# VOLVO

## Service Manual Supplement

TP 30941/1S

Manual transmissions  
M46, M47, M47II  
including types J & P  
Overdrives  
200/700

## New hydraulic plungers in J, J/P and P overdrives

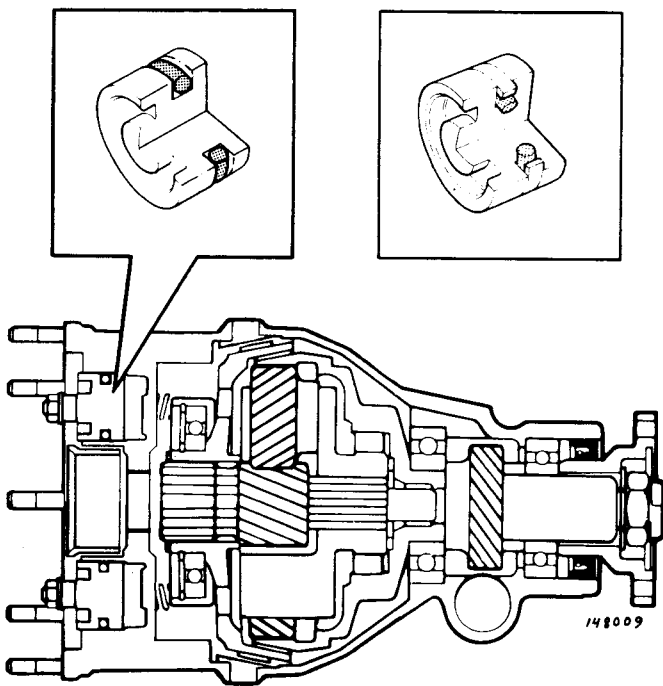
Hydraulic pistons with improved seals were introduced progressively in type J, J/P and P overdrive units during model year 1988.

The new seal consists of a heavy O-ring, replacing the existing O-ring and Teflon sealing ring. The seal is made of a more durable material and reduces the risk of fluid leakage.

The modification is effective from the following type, part and serial numbers:

When reconditioning type J and J/P overdrive units incorporating the earlier design hydraulic pistons and it is noticed that the Teflon rings are worn, the pistons should be replaced by the new type pistons P/N 6814454-2 and new O-ring seal, P/N 6814455-9.

## Mainshaft modifications and new circlips

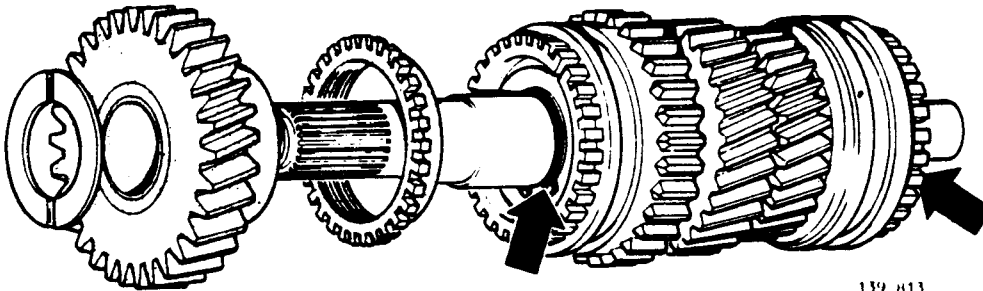
Mainshaft modifications and new circlips have been introduced and in production since transmission part number 1208427-3 (running number 138176), 1208428-1 (running number 104767) and 1208430-7 (running number 134471). These modifications have been done to counteract loose or broken circlips. The new circlips are 1.75 mm thick; original equipment circlips were 1.50 mm thick. To accommodate the thicker circlips, the mainshaft circlip grooves (as shown in the illustration below) were also made wider.

If during transmission assembly, the original circlips show signs of wear, install the new circlip P/N 968700-5 onto the original mainshaft with a narrow groove. In such a case, ensure that the circlips are firmly pressed into position.
